# Staff Report

Devens  
Enterprise  
Commission

**RE:** Bulge/Patton Intersection Realignment Project

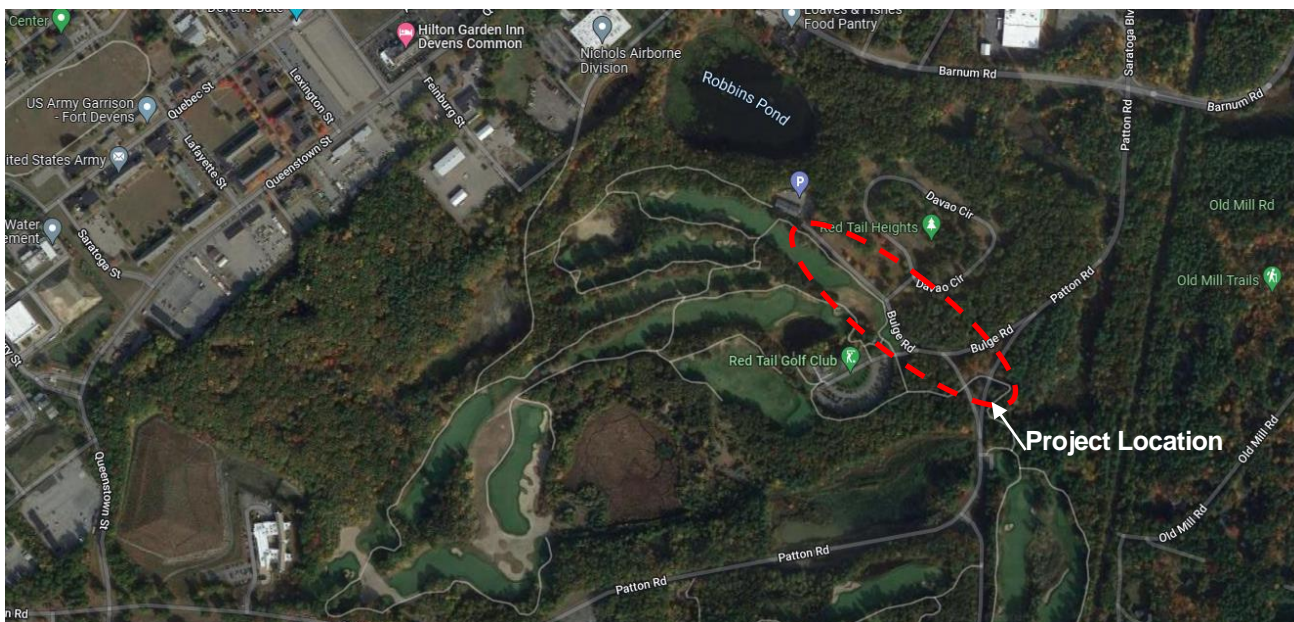
1. Roadside swales. Sheet C601 cross sections only show swales from Sta. 21+00-22+30. There appears to be ample room to install drainage swales along the south side of the upper portion of the street as well.
2. Plans show Bulge Road being narrowed down to 10' travel lanes but 3' shoulders in some areas seems like an added opportunity for additional impervious surface reduction and slower and safer streets.

1. The DEC requires vertical granite or cement concrete curbing on all sidewalks that directly abut the road.
2. A stonedust trail connection to the north along the existing roadway that is to be eliminated would connect to the Markley Range Trail. This is an important connection to the rest of the Devens Trail network and is consistent with the Devens Main Post Trails Plan and Devens Open Space and Recreation Plan.
3. All plans need to show existing trees marked for preservation and trees proposed to be removed along with protection for trees to be preserved that are within the limits of work.
4. Landscaping details should also be provided for swales and all exposed areas and clarify which areas are to be maintained mowed areas (minimized) and conservation/meadow seed mixes for areas that require less mowing/meadow areas. Street trees are required on both sides.
